1.0 Dimension comparison

2.0 Physical differences

3.0 Affected devices for BGA (Y)

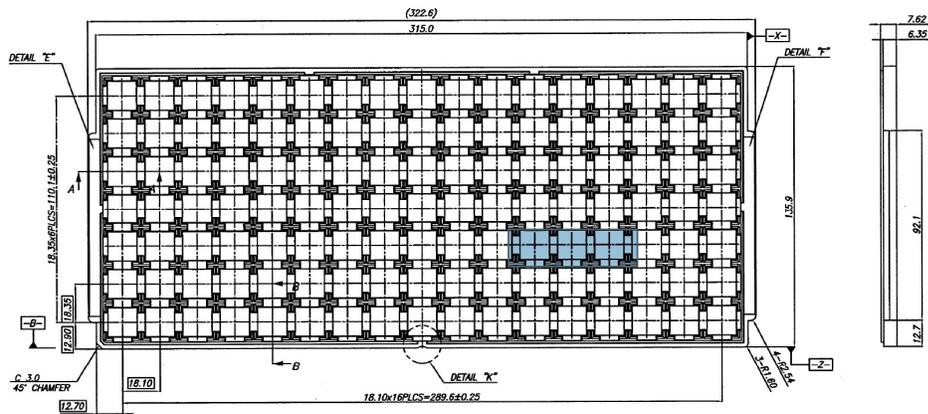
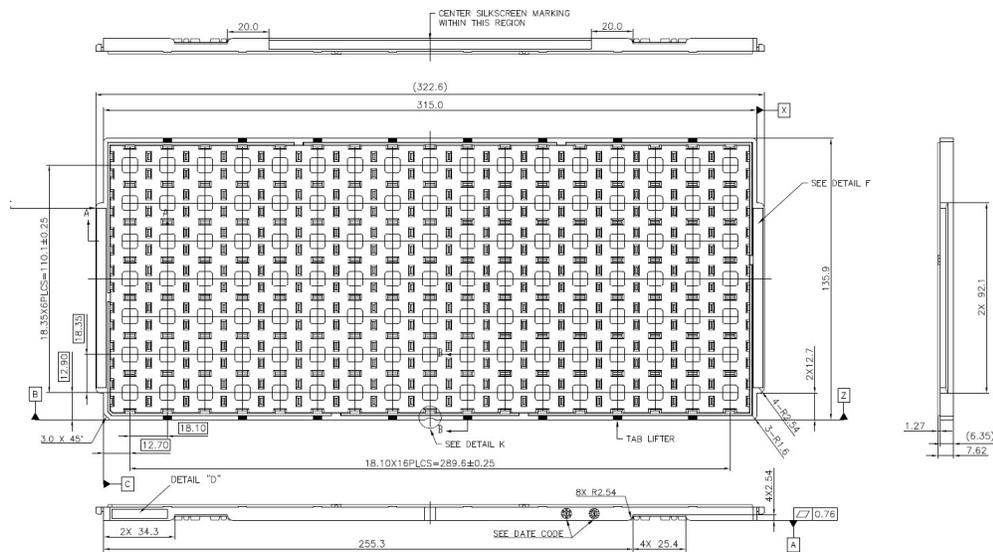
There is no significant change to the dimensions of the tray.

Note: The tray 50-8068 and 50-8001 not stackable with each other due to pocket tray wall design is different. There will be a gap in between both tray when 50-8068 stack on top of 50-8001 or 50-8001 stack on top of 50-8068.

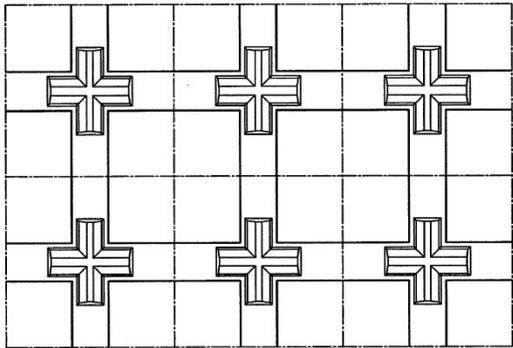
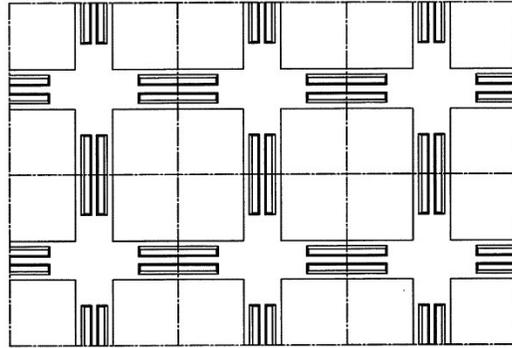
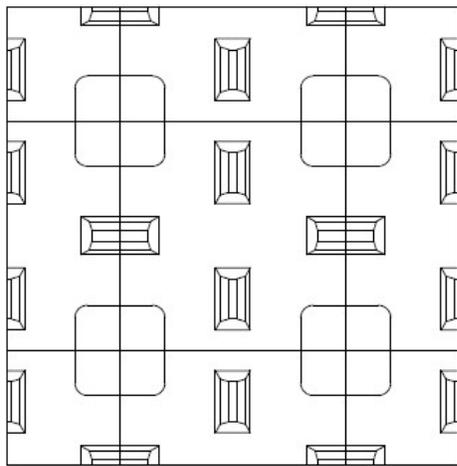
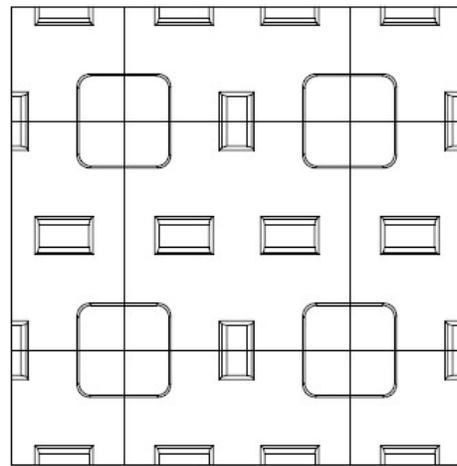
Both trays have silk screen printing indicating the tray part number, 8001 for 50-8001 and 8068 for 50-8068.

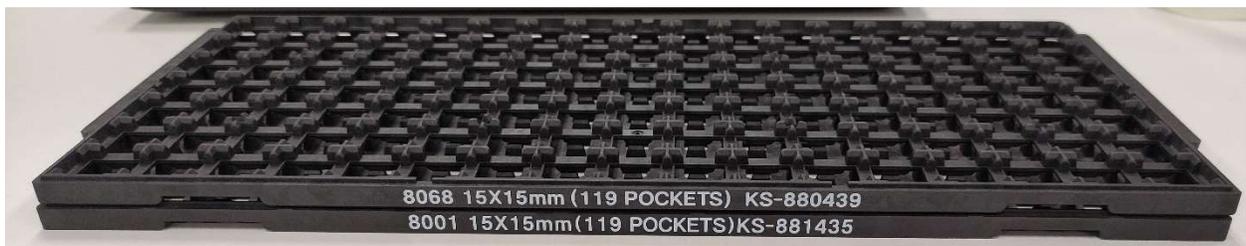
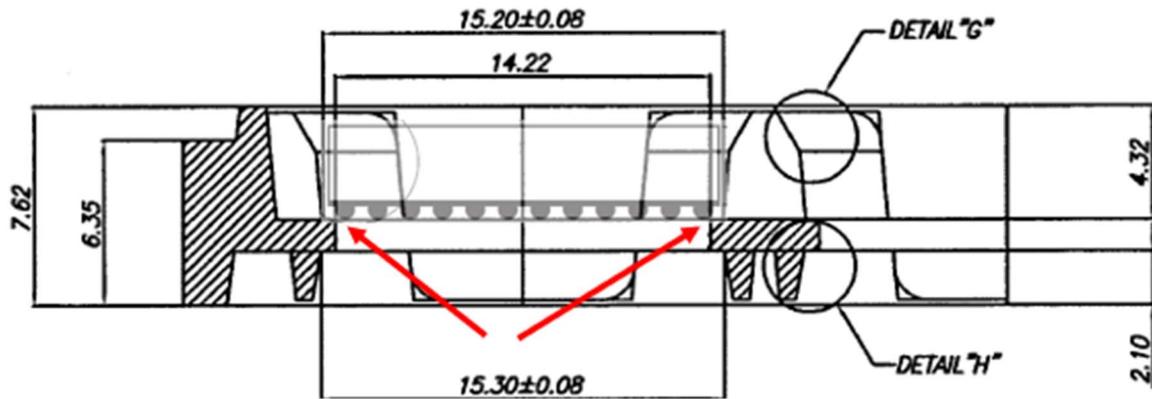
Tray 50-8068 solder ball at the perimeter of the unit will be sitting on the edge of the tray pocket.

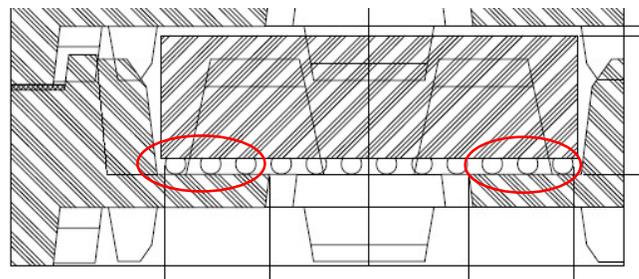
Tray 50-8002 solder ball 3 row on the left and 3 row on the right of the unit will be supported by the tray.
